Re: PUCO Case No. 16-2438-RR-FED- In the Matter of a Request for the Installation of Active Warning Devices at IORY Railroad Crossings, DOT#151-970W, Cuba Road, & DOT#151-957H, Doan Street, in Clinton County, Ohio.

TO: Randall Schumacher, Supervisor, Rail Division, PUCO
FROM: Cathy Stout, Manager, Safety Section, ORDC
BY: Greg Gronbach, Project Manager, Safety Section, ORDC
SUBJECT: Clinton County, Cuba Rd, IORY DOT # 151970W, PID 103318
DATE: December 12, 2016

TO: Randall Schumacher, Supervisor, Rail Division, PUCO
FROM: Cathy Stout, Manager, Safety Section, ORDC
BY: Greg Gronbach, Project Manager, Safety Section, ORDC
SUBJECT: Clinton County, Doan Street, IORY DOT # 151957H, PID 103223
DATE: December 12, 2016

DOAN ST - MP 55.55 (151957H)		DOAN STREET SIGNAL UPGRADE	
CALCULATED	DJT	CHECKED	TAS
PROPOSED SITE LAYOUT			
0 10 20 40 HORIZONTAL SCALE IN FEET

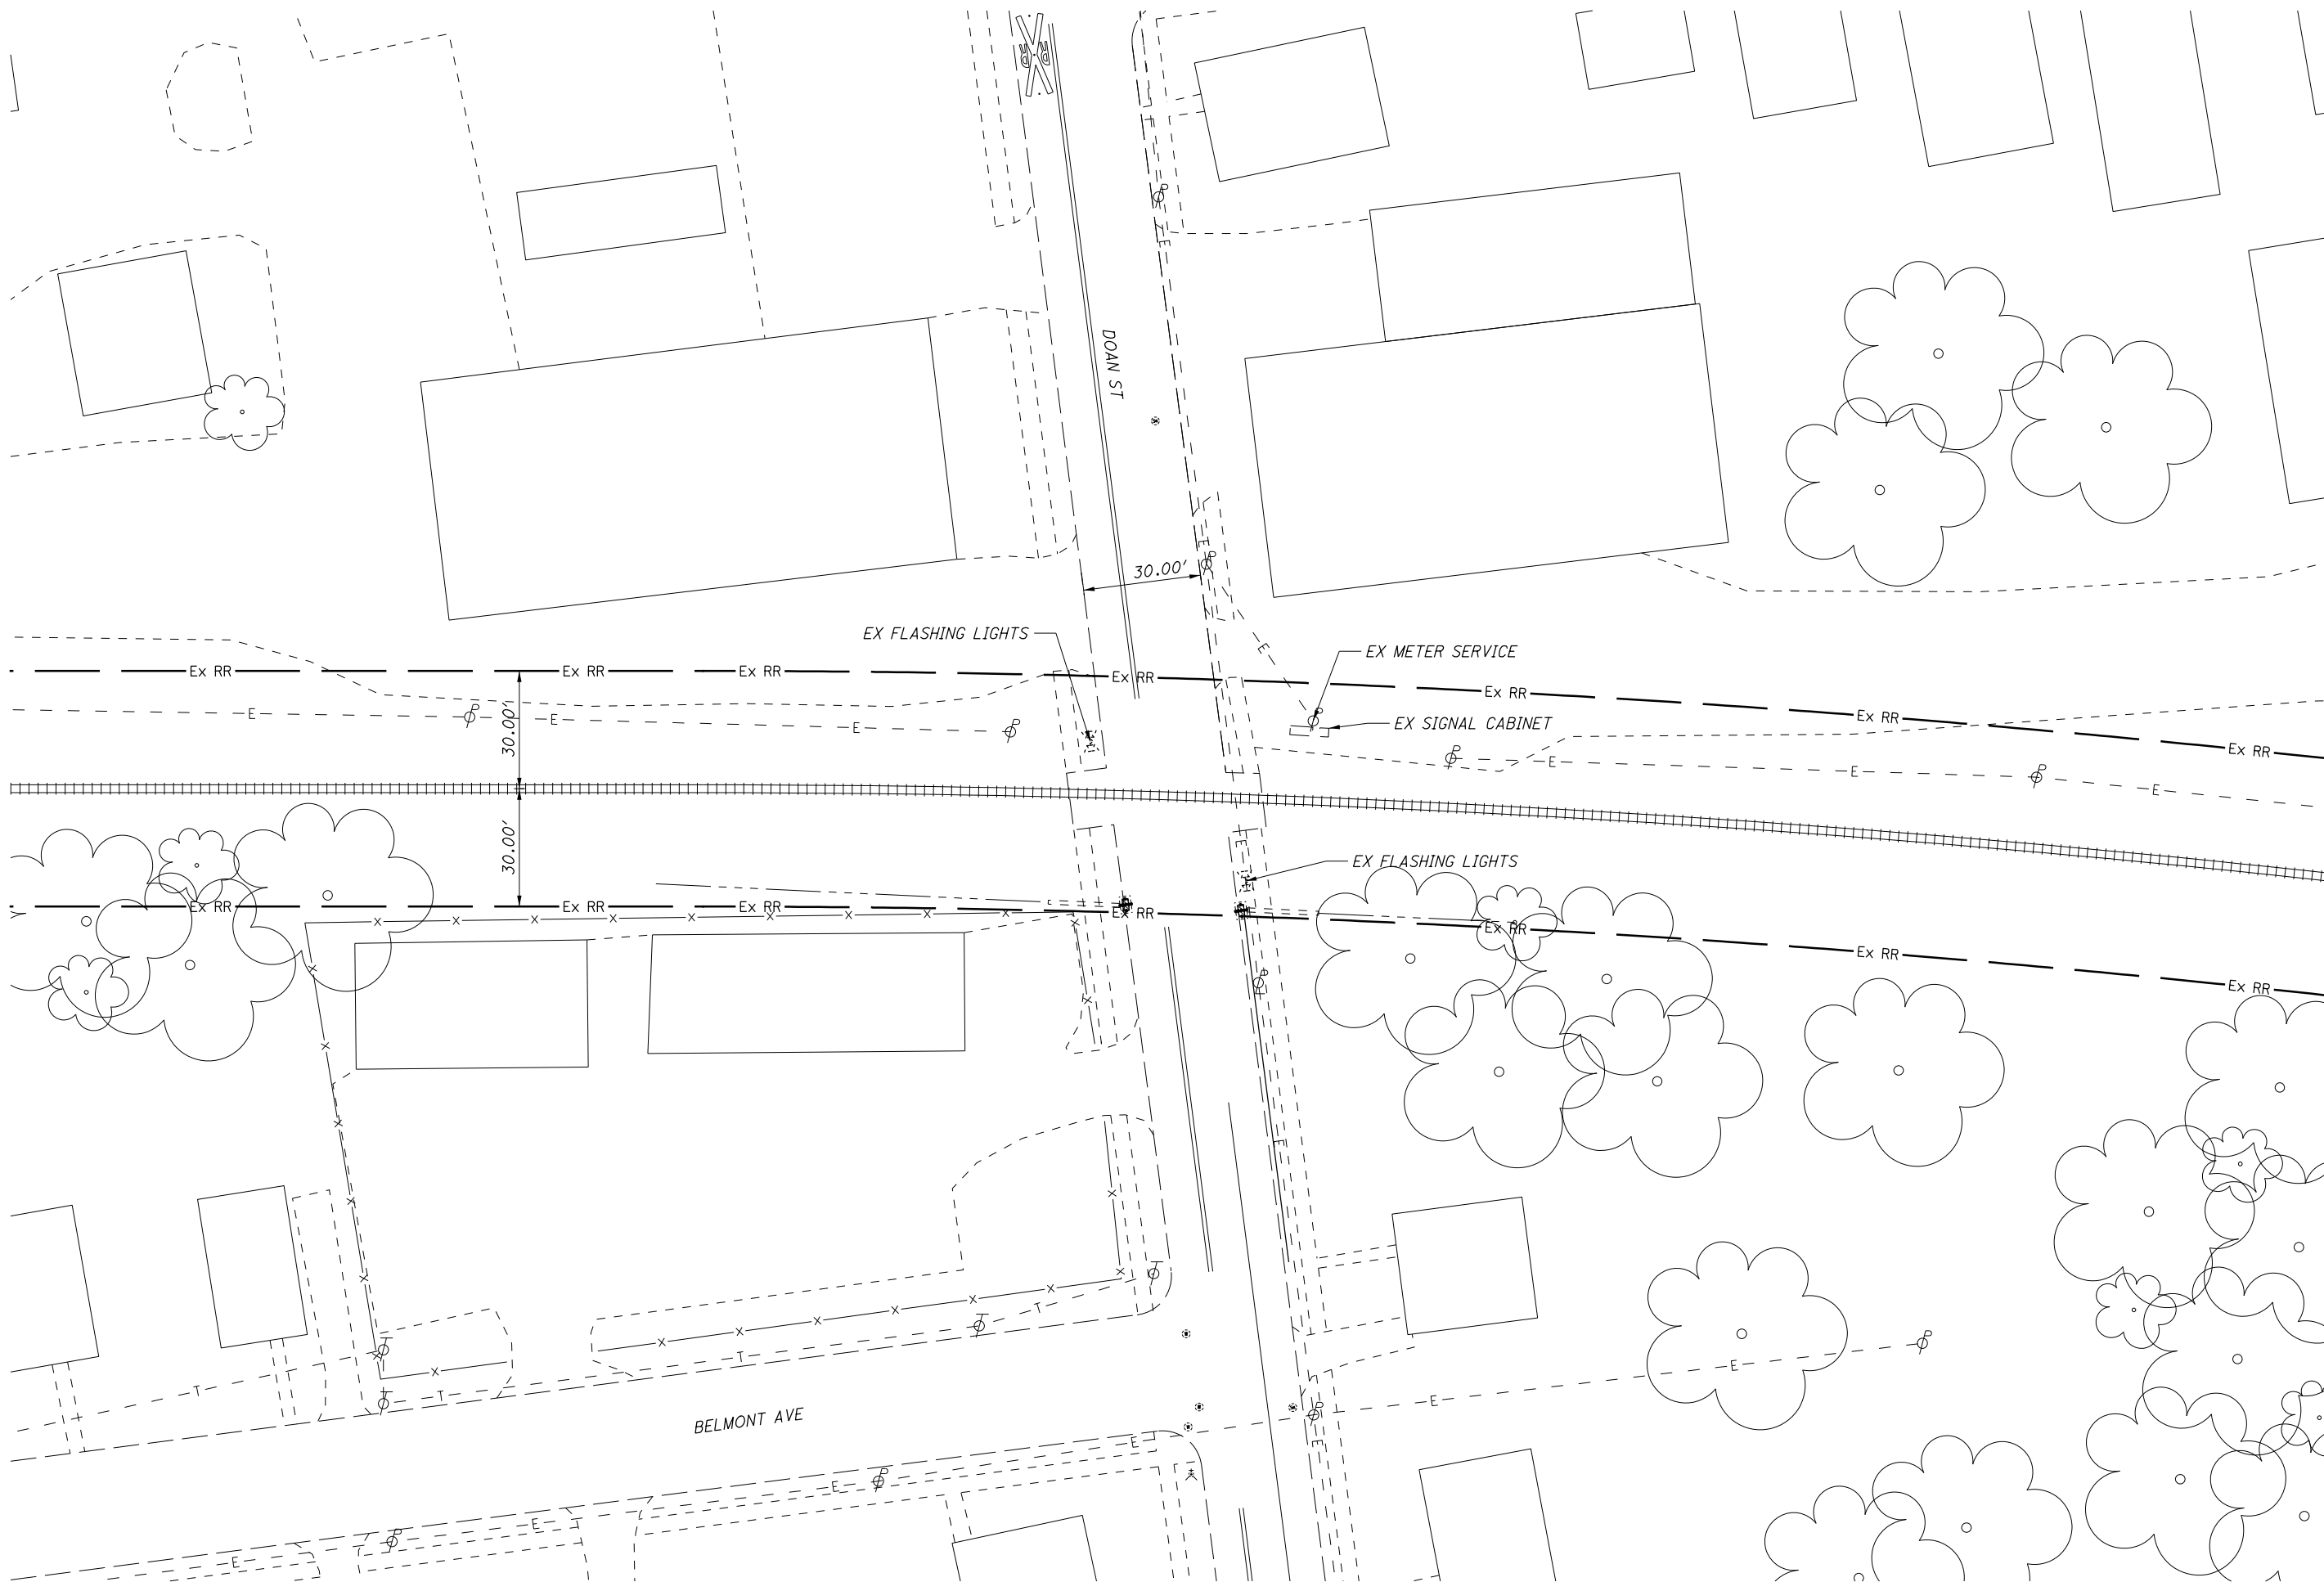
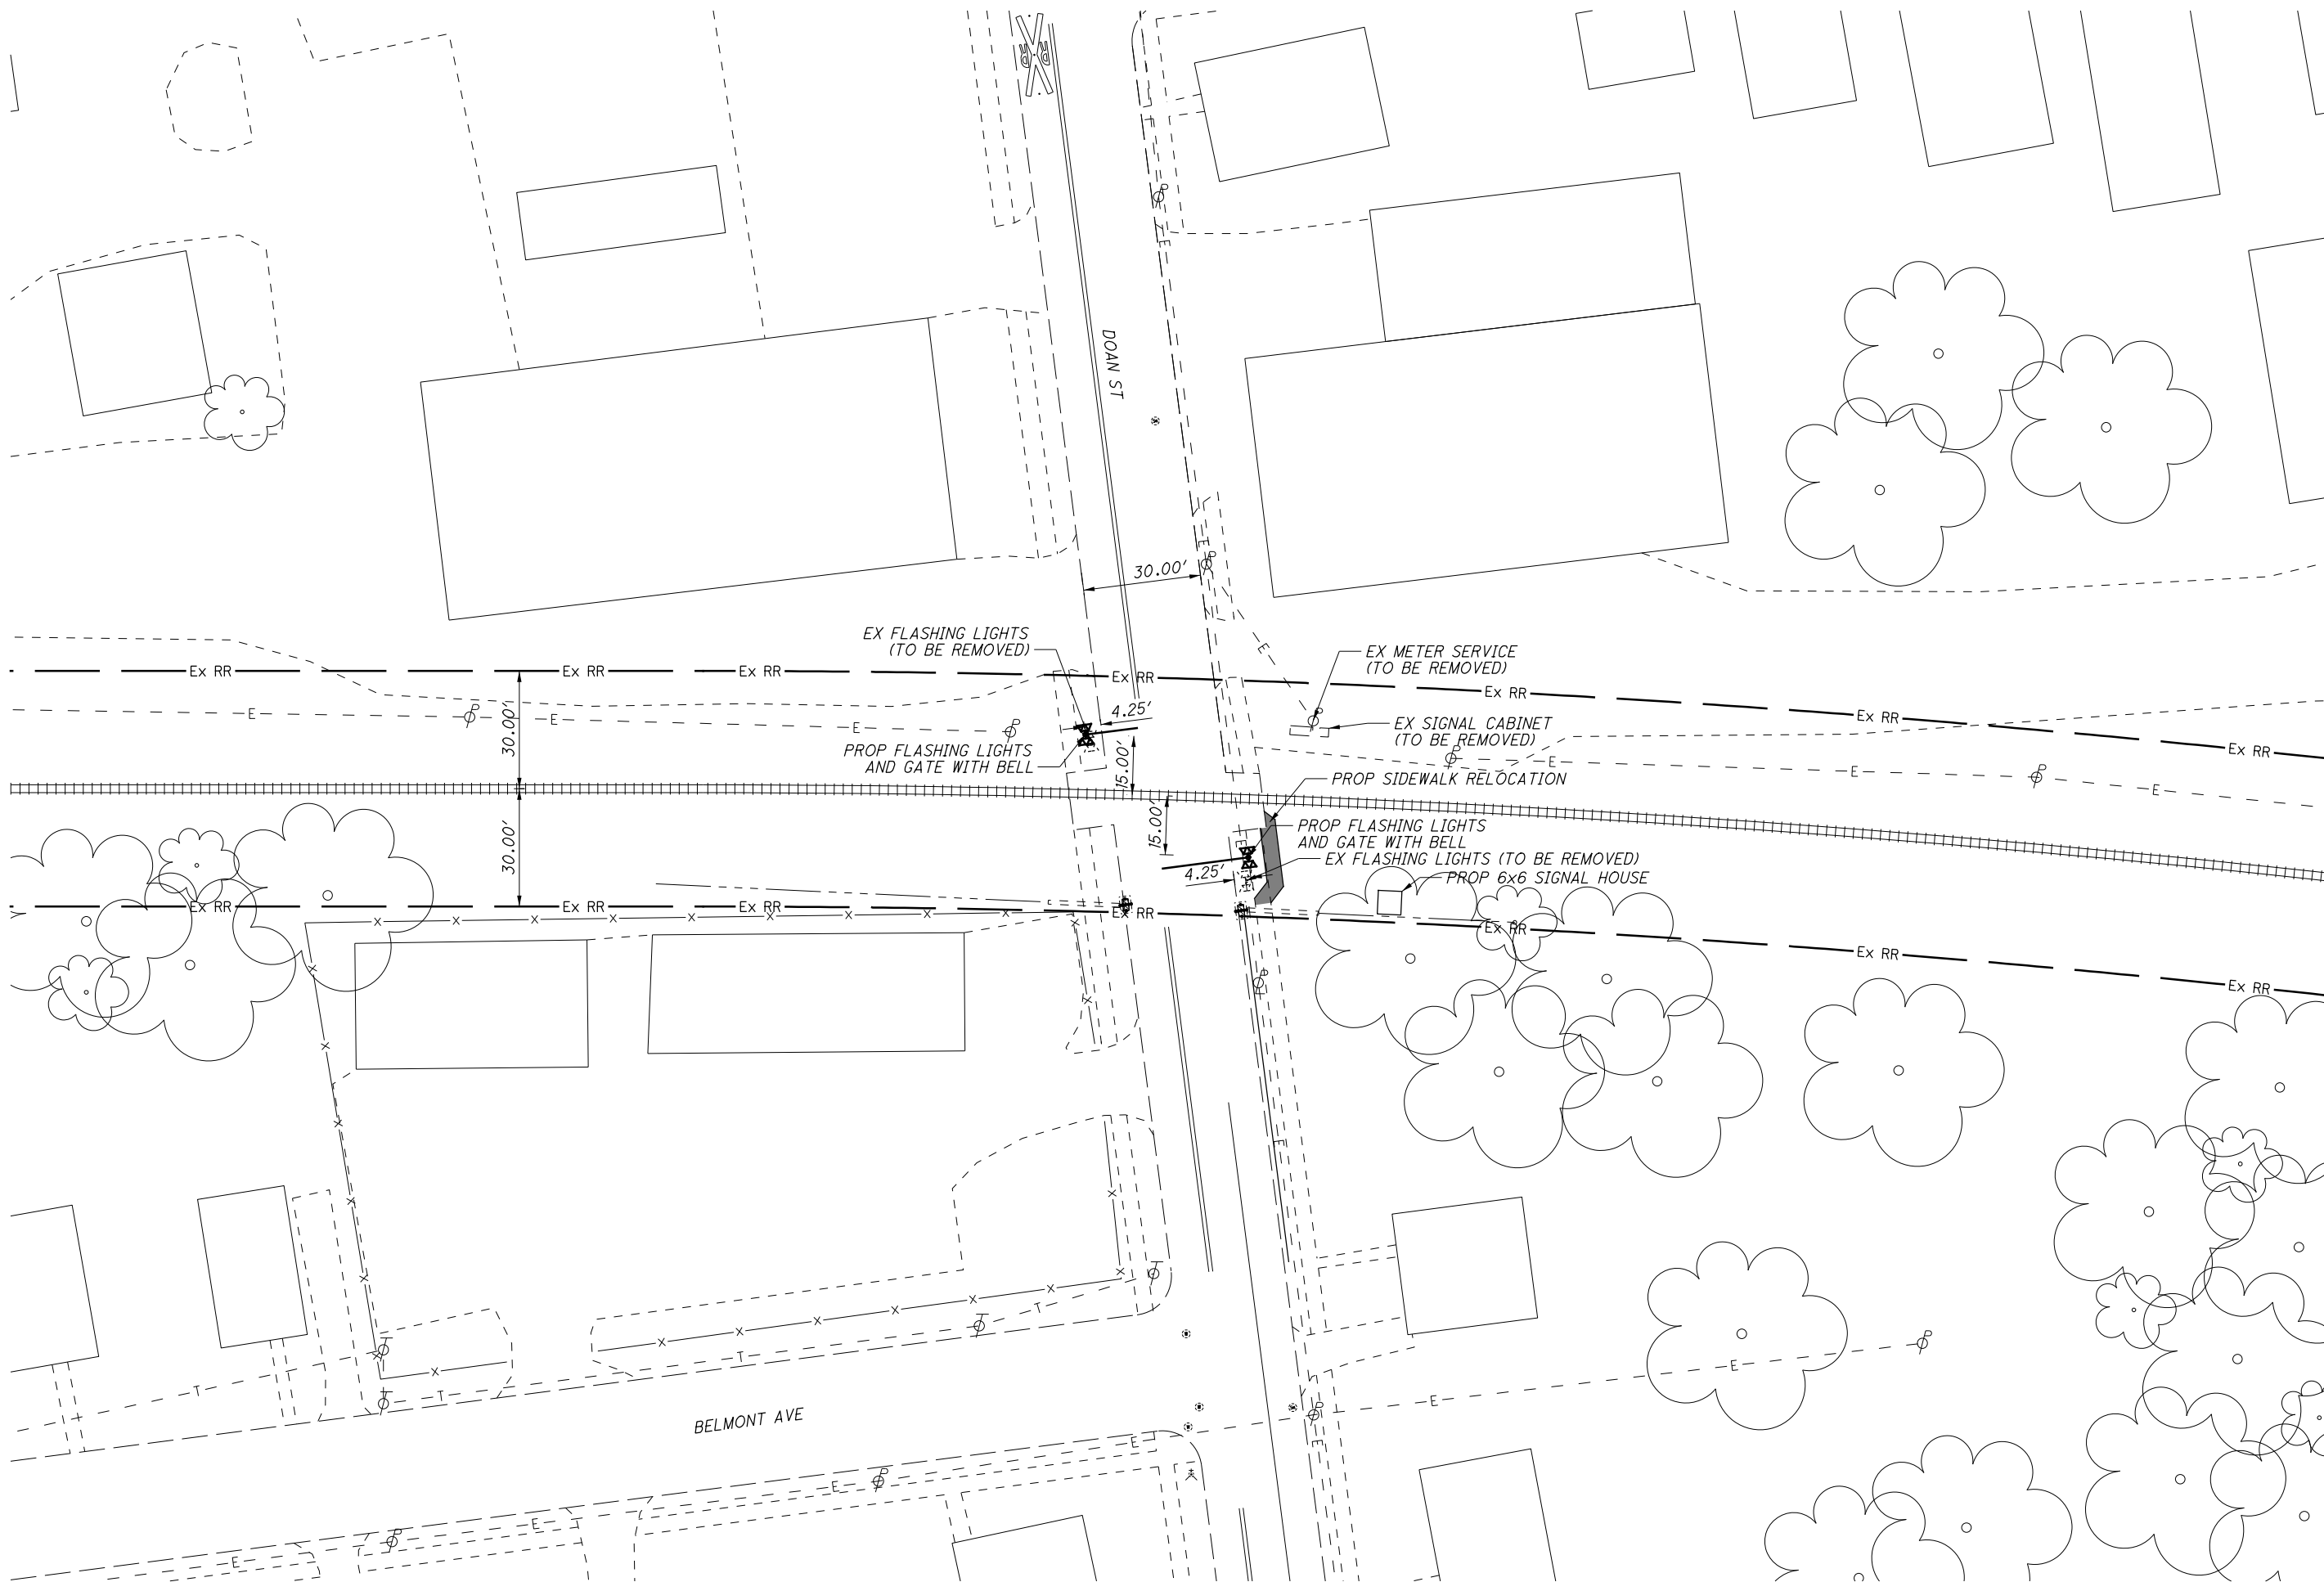
The plan and estimate dated November 18, 2016, for the referenced project has been reviewed and is acceptable. Indiana & Ohio Railroad (IORY) may proceed with the construction of the proposed grade crossing warning system in accordance with the abbreviated plan. Construction may include but is not limited to circuitry design, installation of service poles, procurement of materials and signal construction. Please note ODOT Railroad Audit Circular No.4 Subcontracted Costs for Railroads and accordingly provide ORDC with any relevant bid documents and bid tabs pertaining to this project. This authorization is made with the stipulation and understanding that the approved estimate may contain entries for items or activities that may be cited and found to be ineligible for federal participation during the project audit. Reimbursement of eligible actual cost is limited to \$190,000.00 and will be adjusted based on bid tabulations if applicable. Additional costs must be approved in writing by the Ohio Rail Development Commission (ORDC) prior to being incurred. Emergency verbal authorizations by ORDC may be permitted and will be confirmed by ORDC in writing within ten (10) business days of the verbal approval.

Field Sketch

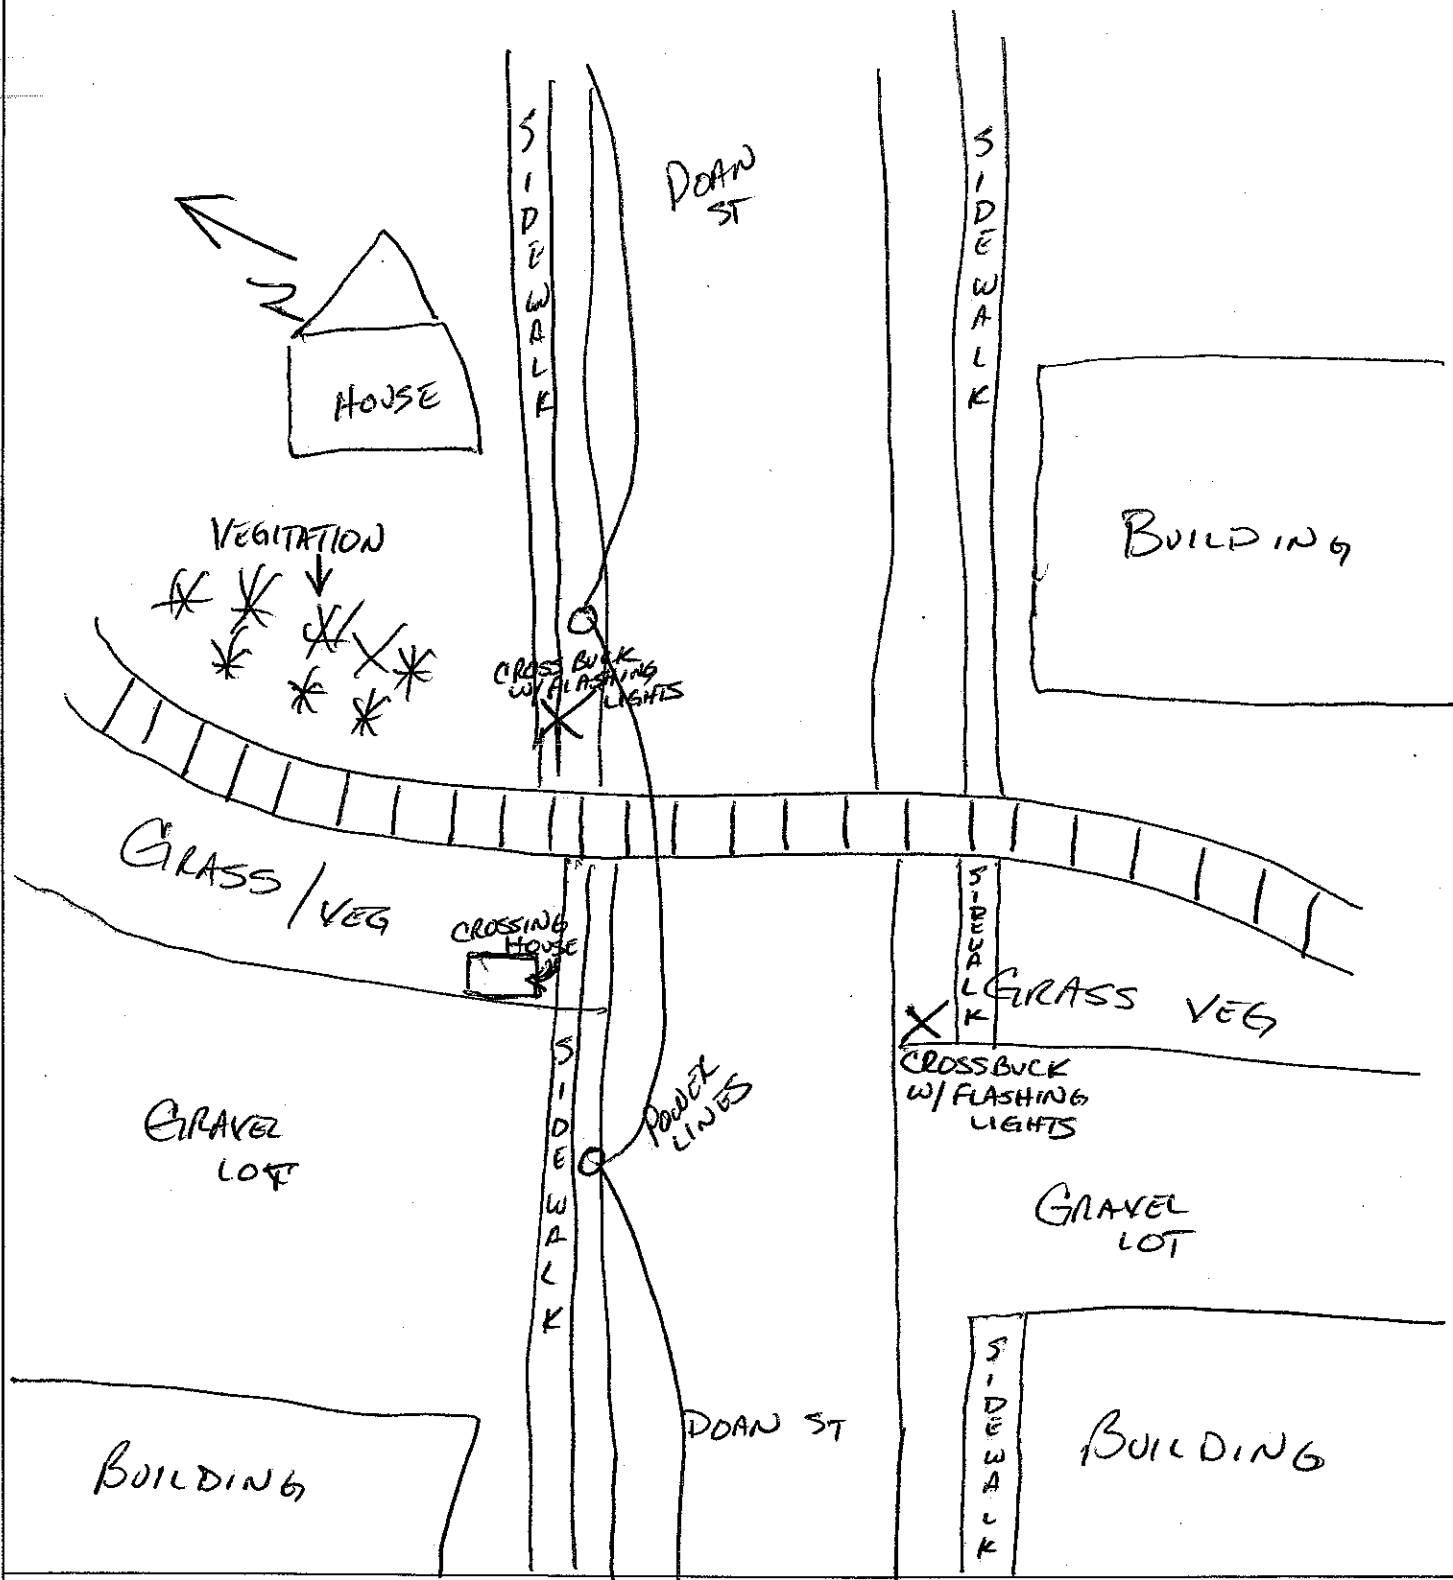
If non-gated crossing, is clearing sight distance adequate in all quadrants? (See Table 1) ☐ Yes ☒ No **NE ROAD HAS VEG THAT NEEDS REMOVED.**

OVERHEAD POWER ON NORTHSIDE OF DOAN ST.

YES - POSSIBLE CLOSURE AT HAWLEY AVE TO THE NORTH.

POSSIBLE SIDEWALK WORK WITH C/G INSTALL.
CURBS OKAY.

Comments: LIGHTS / GATES @ DOAN WITH SURFACE. WOULD LIKE TO INCLUDE ~~US22~~ SURFACE WITH CLOSURE OF HAWLEY AVE TURN HAWLEY AVE INTO CUL-DE-SAC ON BOTH SIDES.
